News Release Winter 2022: Personnel changes and updates in Manuals and Brochures

LK90H balcony door system will be updated to LK90X-system

Pic 1. Old LK90H cross section

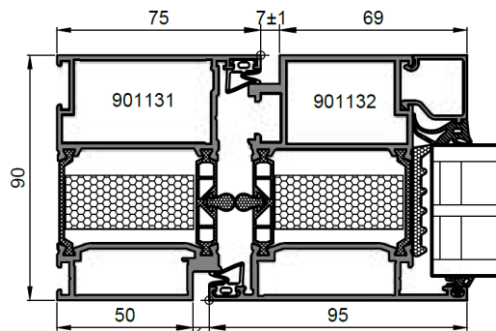
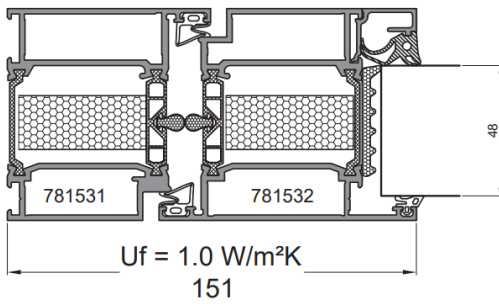
New/ updated:

- Now same than in LK78X -system:
 - Thermal breaks
 - Glazing beads
 - Gaskets
- Hinge selection is updated
 - Hahn R751 -butt hinge will replace Savio and Alpro -models

Pic. 3. LK78X

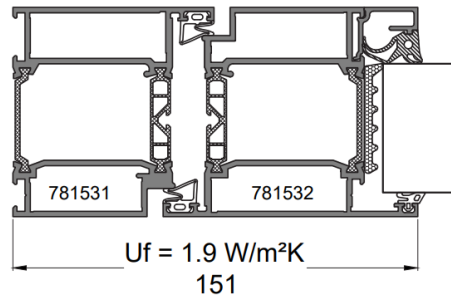
LK75eco, LK78H and LK78 – systems will be removed from the selection

- Old systems in stock will be sold out
- Now and in the future available: **LK78X** and **LK78Xe** systems and **LK90eco**
